# Recall Bulletin

**SUBJECT:** Front-Brake Caliper Leak

**MODELS:** 2015 Chevrolet Colorado  
2015 GMC Canyon  
With Less Than 3,000 Miles (4,800 km)

**Front Caliper Body Casting: Outboard Body**

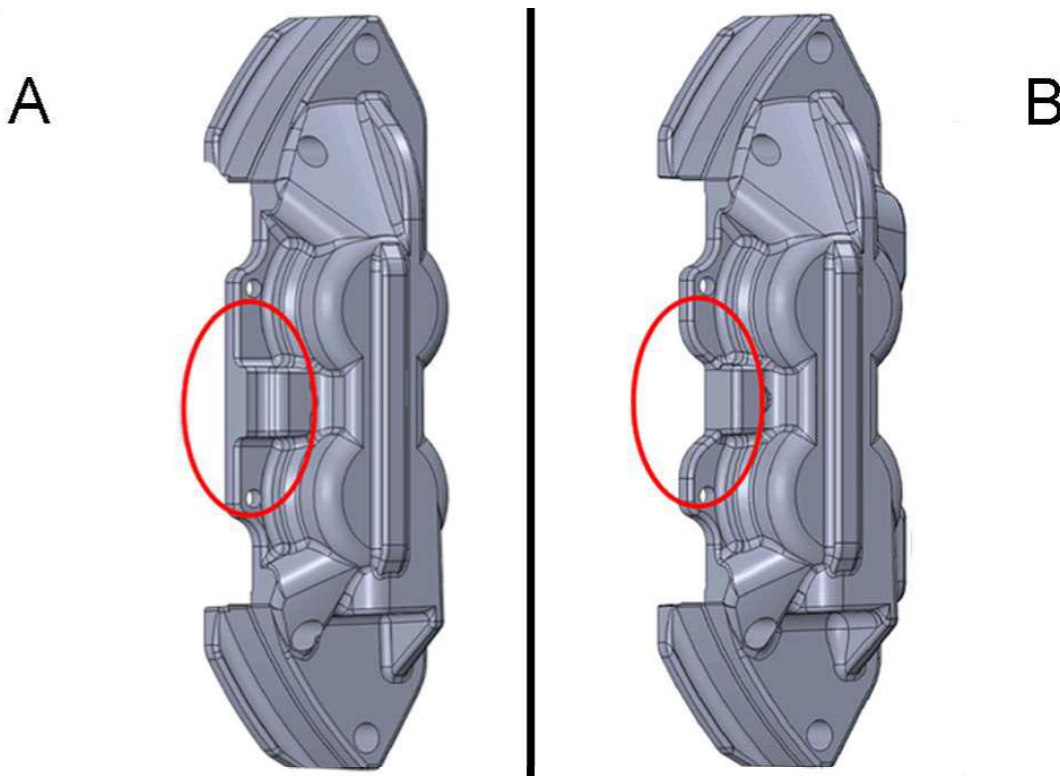
**(A) Original Design Front Caliper Body Casting (B) New Design Front Caliper Body Casting.** The shape of the pin ledge is different between the two designs. Refer to the area in the circles of the illustration to review the differences in the shape of the pin ledge from the original design to the new design.

3. Perform a visual inspection of the front calipers to determine the body casting design of the caliper.
    - If the vehicle is equipped with the original design front caliper body casting, remove and replace both front calipers. Proceed to step 4.
    - If the vehicle is equipped with the new design front caliper body casting, no further action is required. Install the tire and wheel assembly and lower the vehicle. Refer to *Tire and Wheel Removal and Installation* and *Lifting and Jacking the Vehicle* in SI.
  4. Remove the front brake calipers from the vehicle. Refer to *Front Brake Caliper Replacement* in SI.
- Note:** Transfer the brake pads from the old calipers to the new calipers BEFORE discarding the brake calipers.
5. Discard the front brake calipers.
  6. Install new front brake calipers to the vehicle. Refer to *Front Brake Caliper Replacement* in SI.
